Punjab Engineering Congress Paper No. 249

Theory of Flow of water on basis of Silt-Soil Factor.
Some Fundamental Formulæ and their application.

PUNJAB ENGINEERING CONGRESS
 1941.

PLAN OF LAHORE BRANCH.

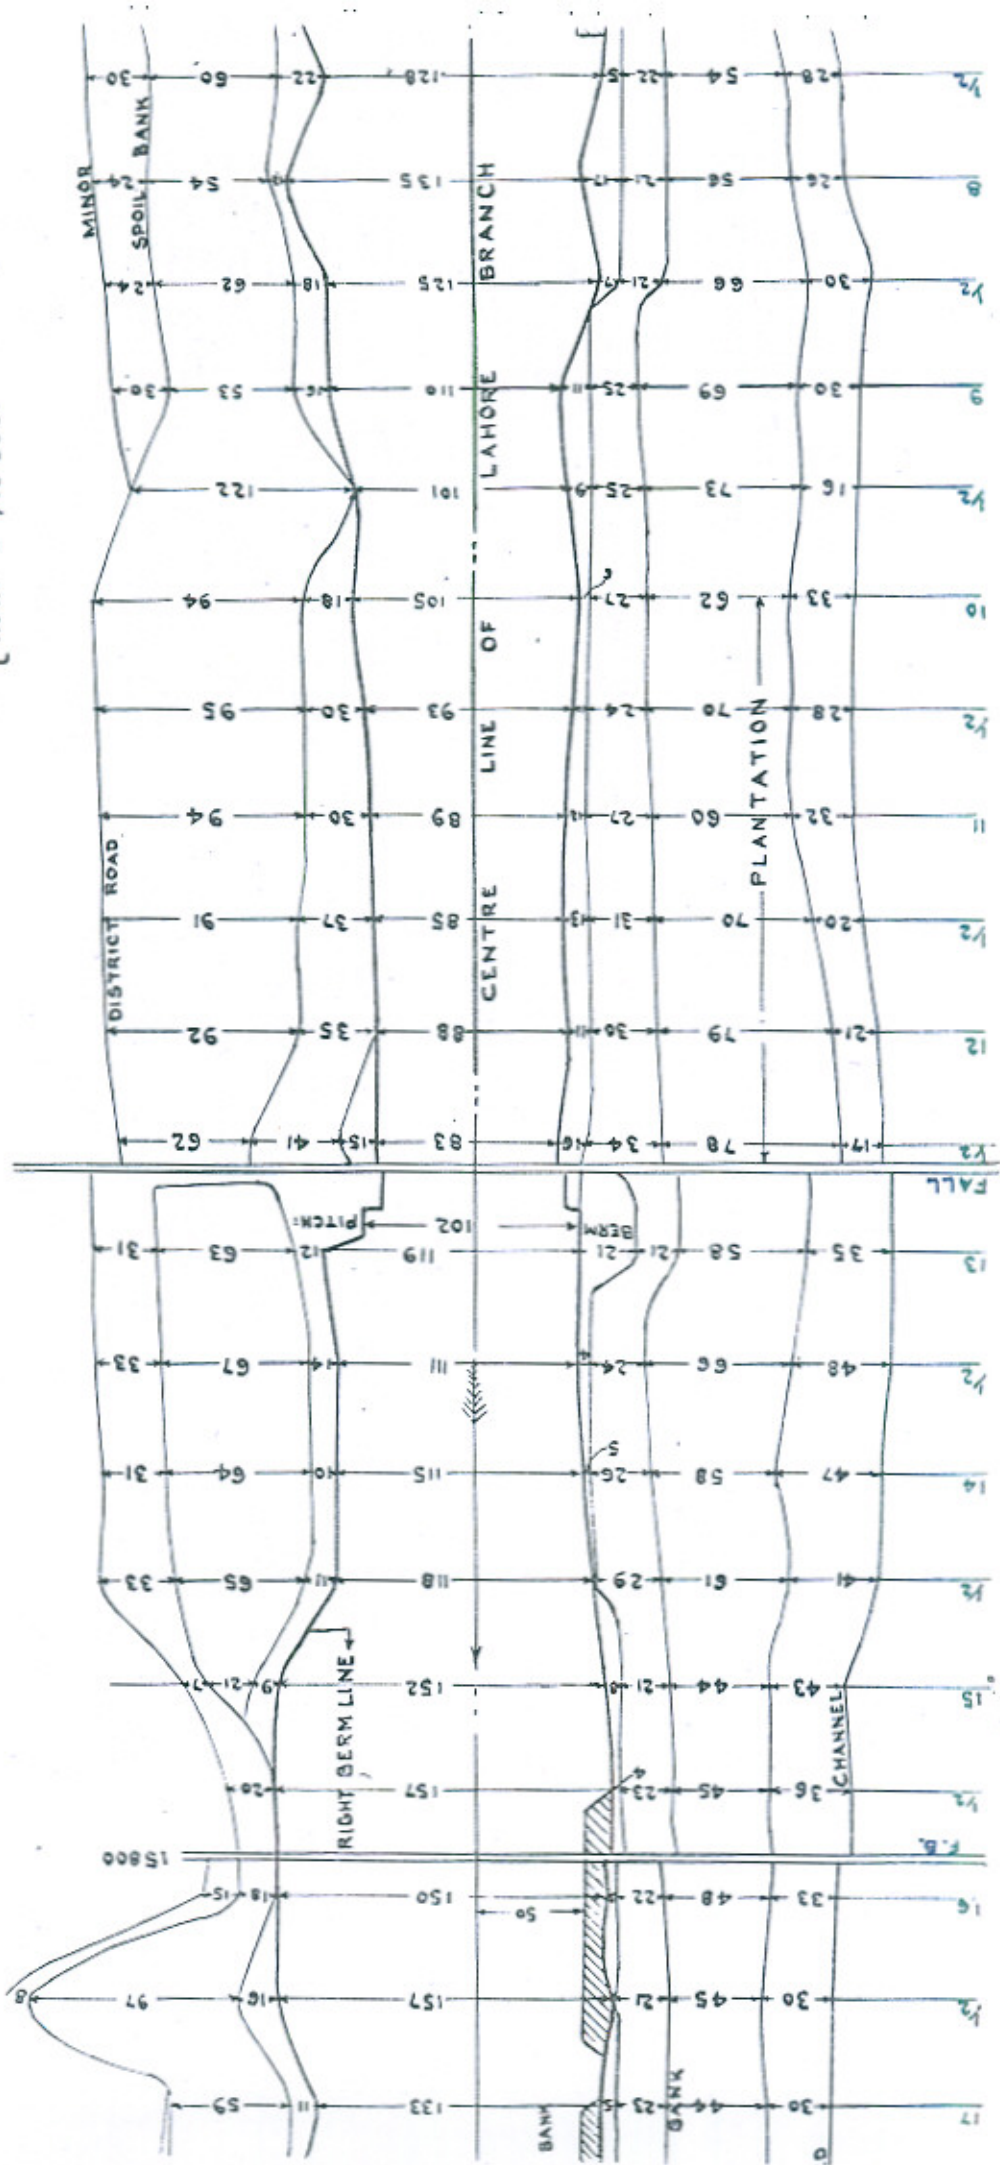
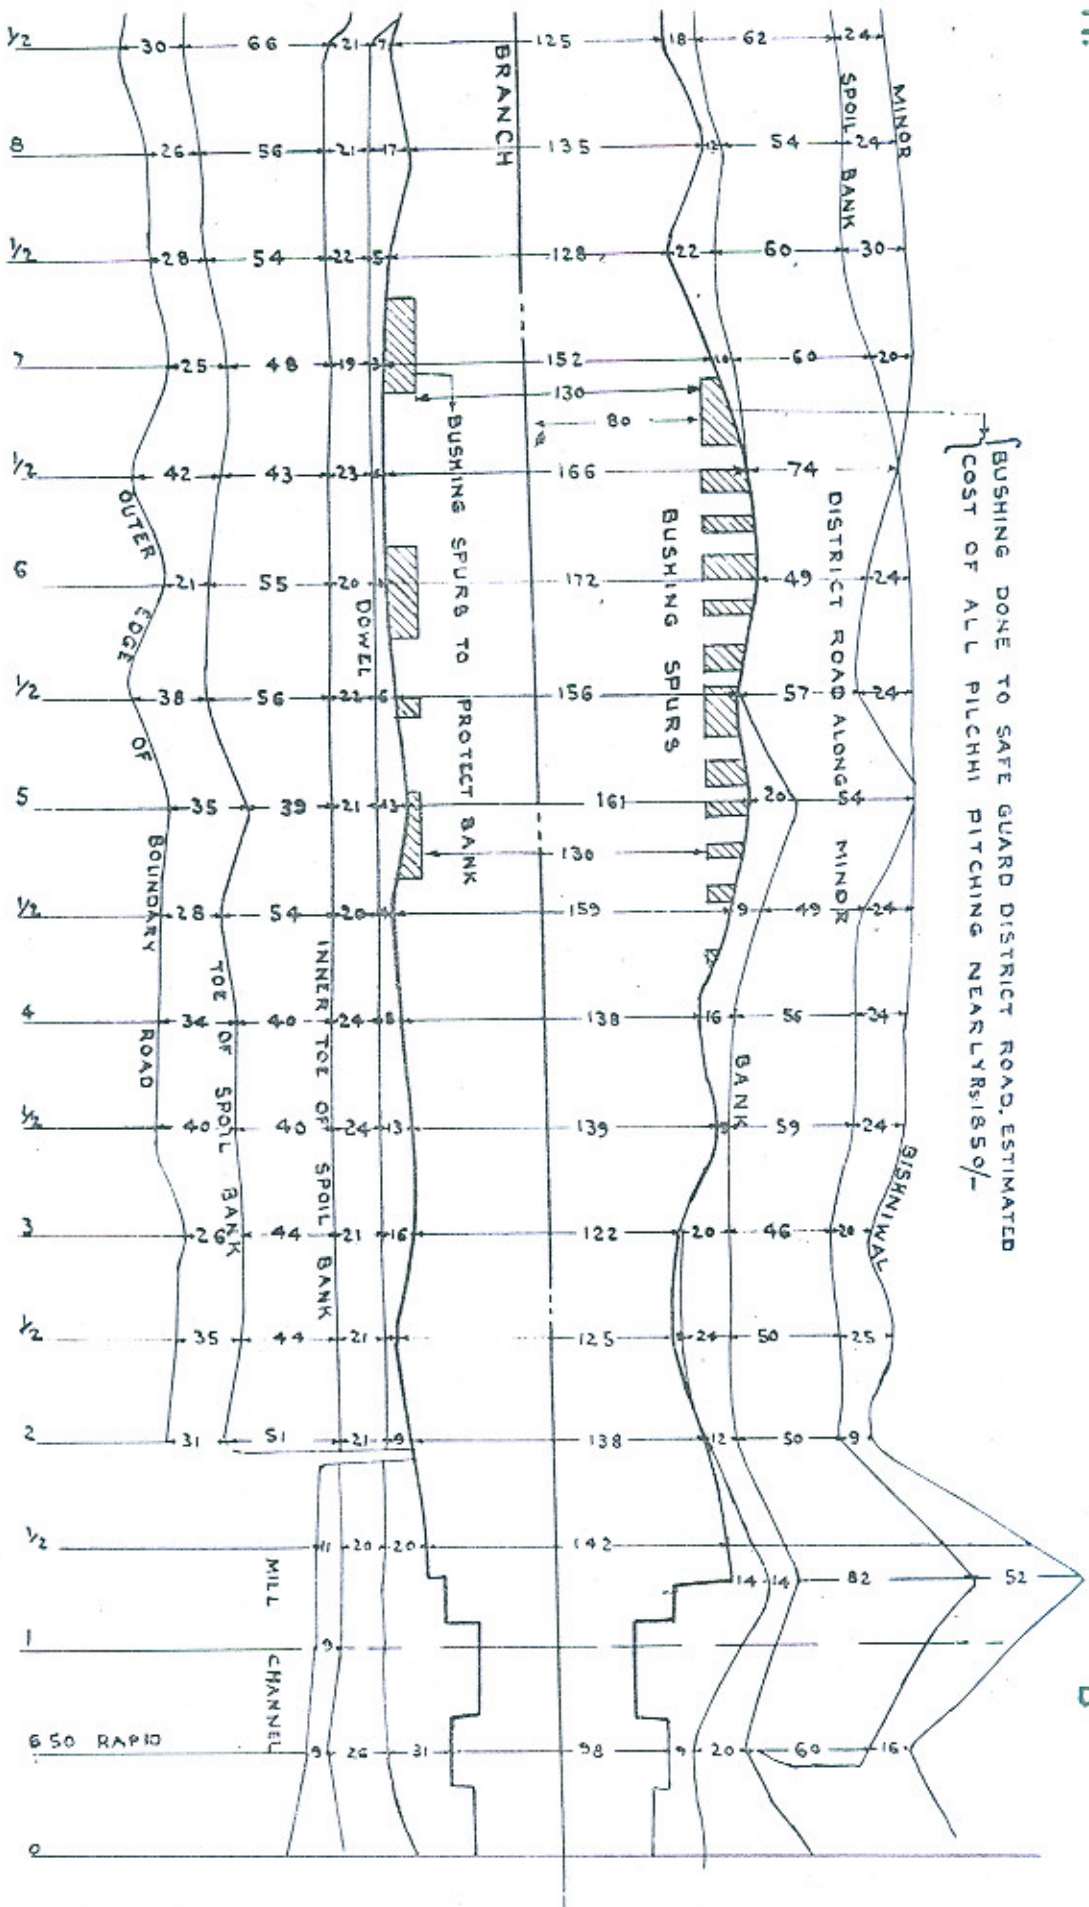
MR. H. L. WADHERA said that the author's remarks on the so-called staking and bushing done at the Head of Lahore Branch were presumably not based on a full appreciation of facts and circumstances of the case. This staking and bushing was a cheap type of bushwood pitching on the lines of pilchi pitching which was resorted to for protection against side-erosion that was proceeding apace in this

reach. The soil in this reach was very soft and the lowering of the crest of fall R. D. 12,500 Lahore Branch had resulted in side erosion in this reach, so much so that on the right side the erosion had reached the District Board Road and threatened to engulf the left bank of Bishniwal Distributary. Steps to protect the sides against further erosion had been taken by means of a cheap type of bushwood pitching, which proved very effective.

In reply to Mr. H. L. Wadhwa, the author said that if the work in question had been done on proper alignment to define section of the channel, all that Mr. Wadhwa had in view would have been achieved in addition to improving the hydraulics of the channel.

AUTHORS REPLY TO MR. INGLIS

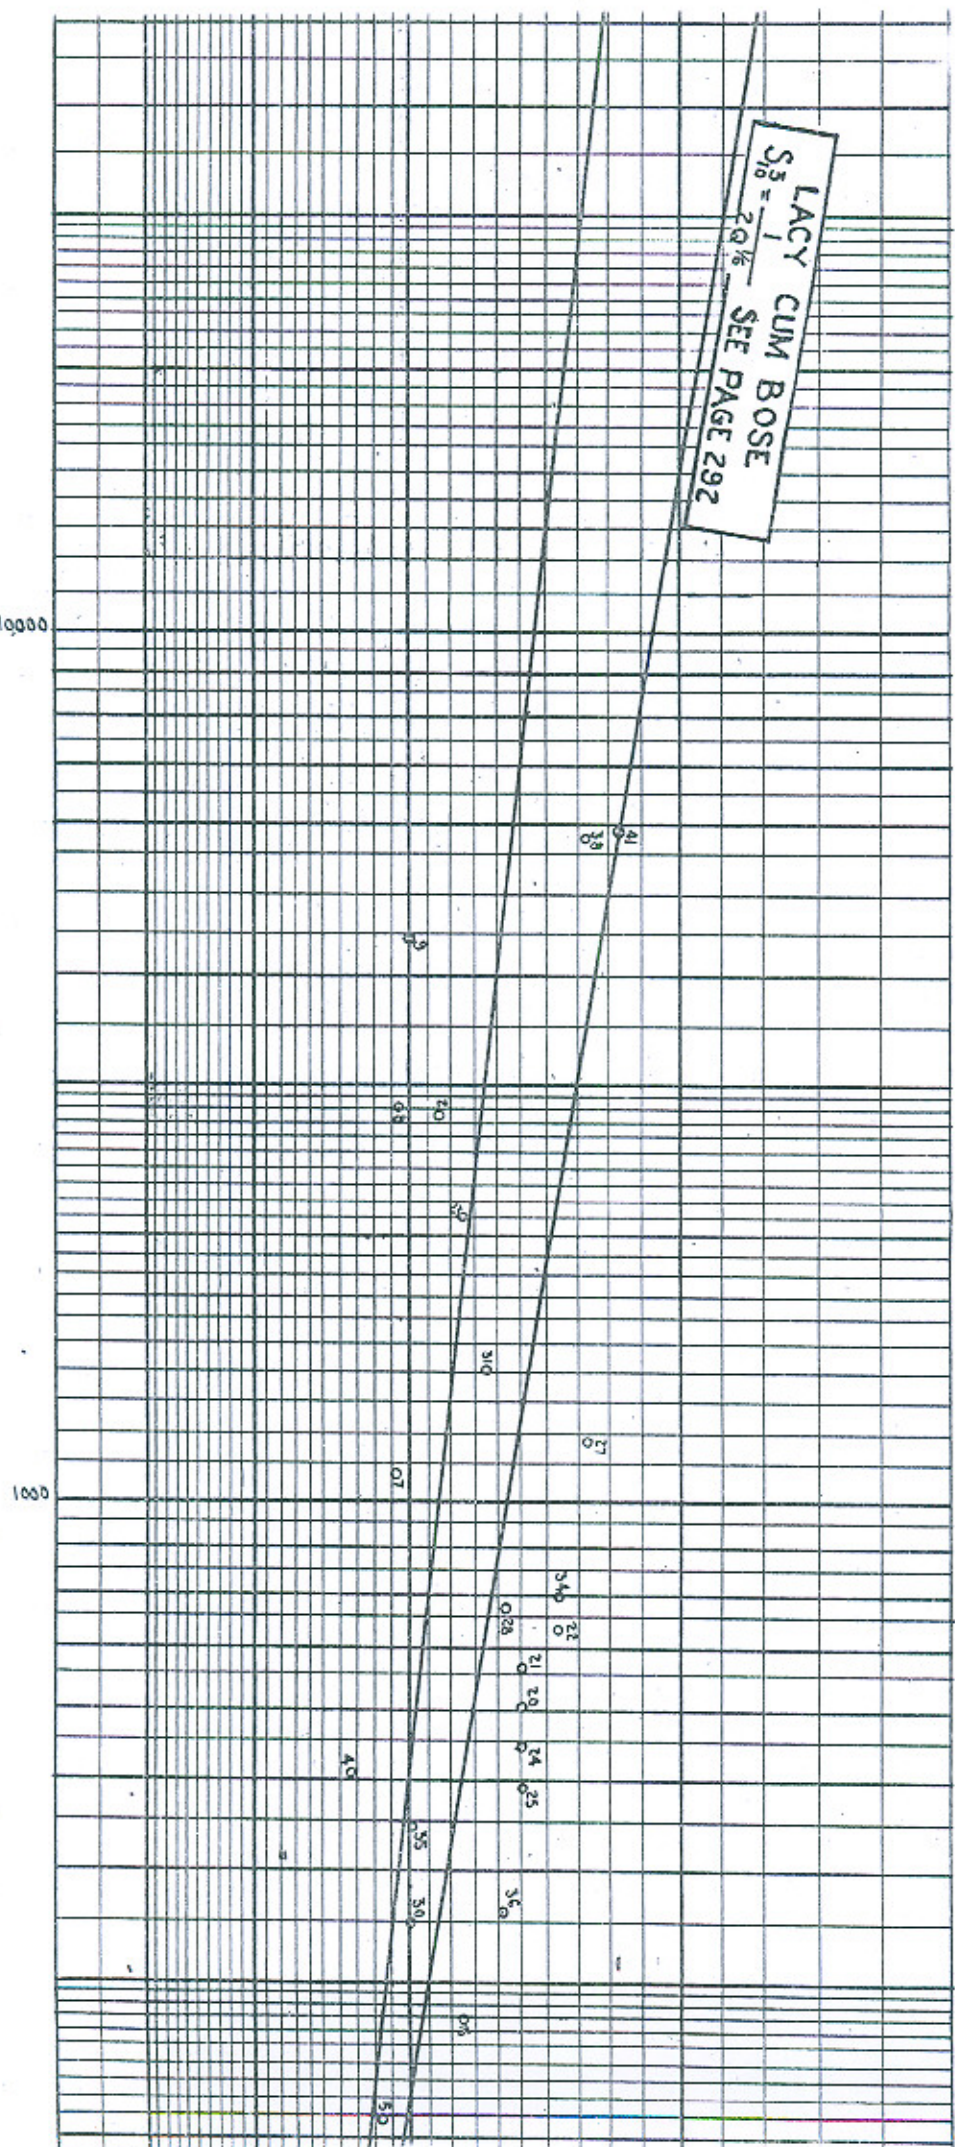
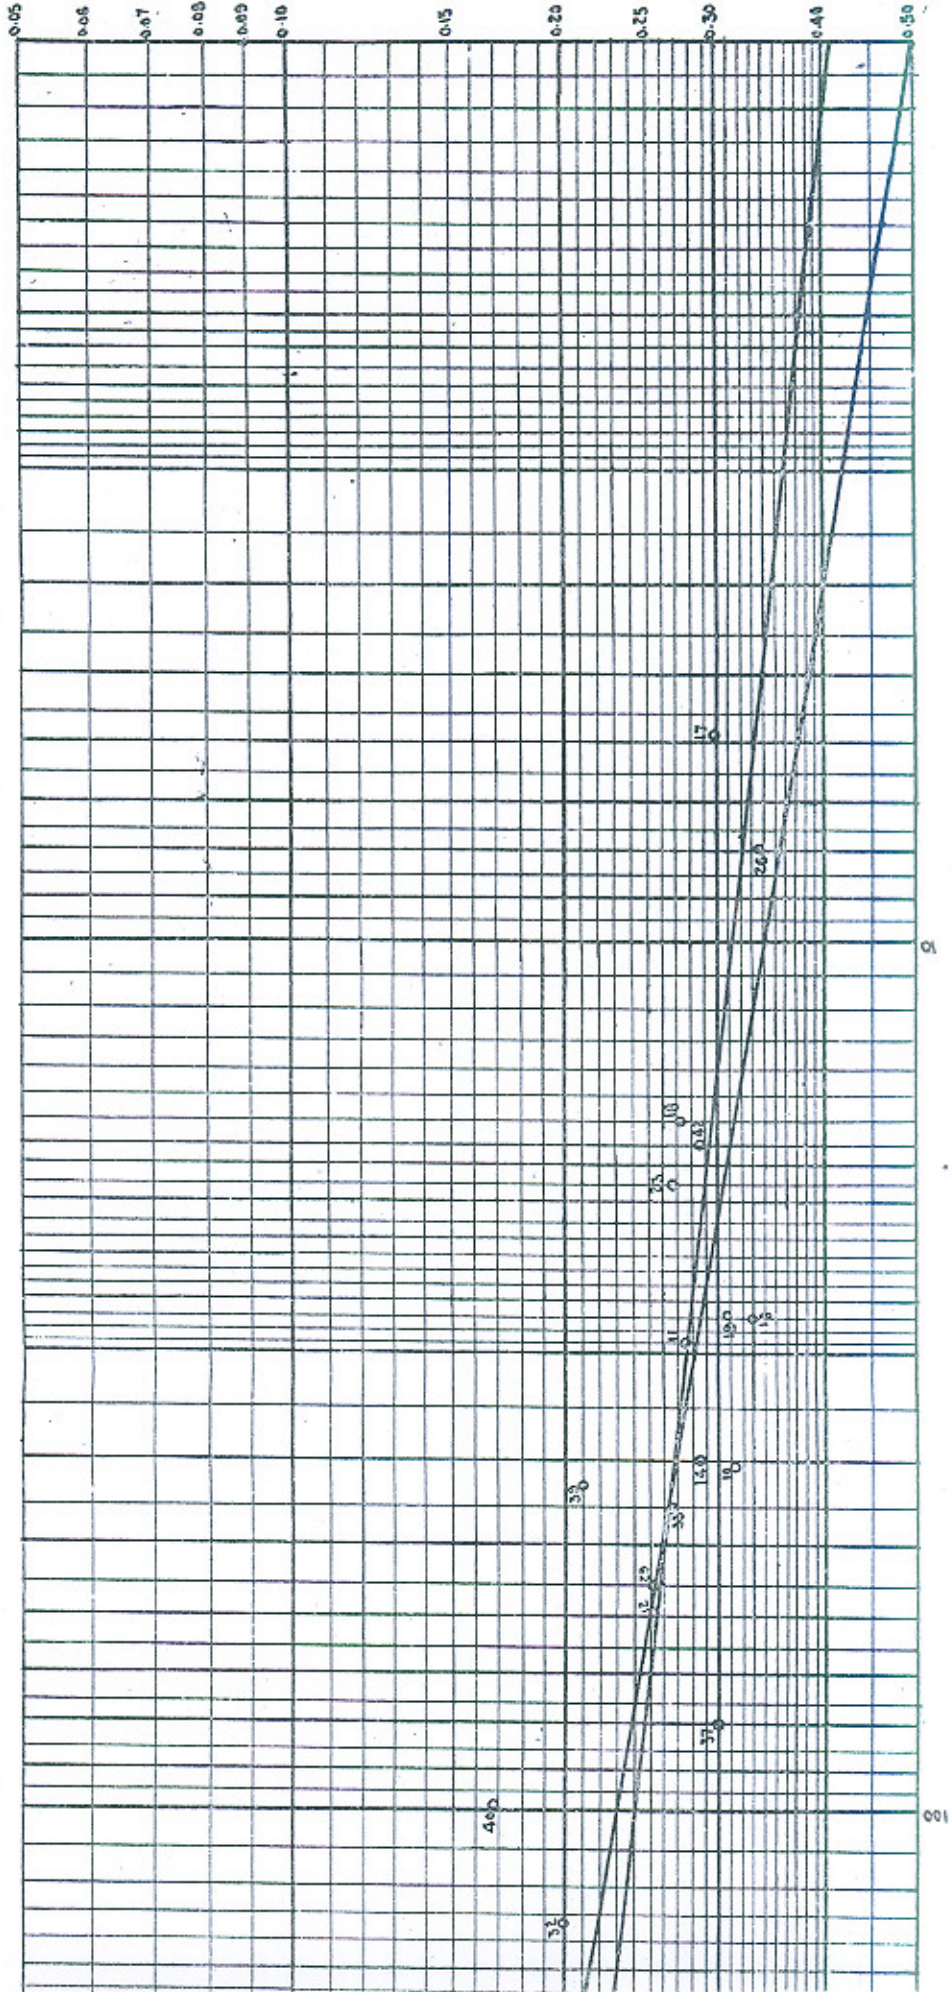
Replying to Mr. Inglis, the author thanked him for his kind appreciation of the Improved Kennedy's diagrams and expected that after a certificate from a high authority, like Mr. Inglis, they will be adopted by irrigation engineers. Regarding juggling with empirical formulæ, the author stated that Mr. Lacey had also by a similar process arrived at his equation $P=2.668\sqrt{Q}$, which in spite of the wide range of variation of coefficient from 2.0 to 3.2 had been applauded universally. Mr. Inglis has stated that the author has juggled with empirical formulæ so that clarification of the subject in earlier parts is stultified by the confusion towards the end. Thus in one formula S varies as $\frac{Q}{R^{10/3}}$ which means that larger the discharge, steeper the slope, which is the opposite of fact. The author said that this conclusion was wrong and in support showed graphs for Shanta Slope formula.

(5) In the above four points there has practically been no opposition. The entire opposition in fact centred about the author's Slope formula. The author has stated his case fully in reply to Messrs. Inglis, Montagu and Lacey and in support has attached a chart in

reply to Mr. Inglis. Lacey's Slope formula $S = \frac{f^{5/3}}{1844 Q^{\frac{1}{6}}}$ does not take

into account the shape of the channels as a factor to determine slope whereas the author's equations for slope are in terms of S/Q/R relationships. The author has by method of correlation analysis found a correlation coefficient of .978 in an S/Q/R relationship and finds that shape of channel represented by R has influence on slope. The author is pursuing this case in his next paper. It is yet to be tested by Engineers what equations are more correct, Lacey's or author's.
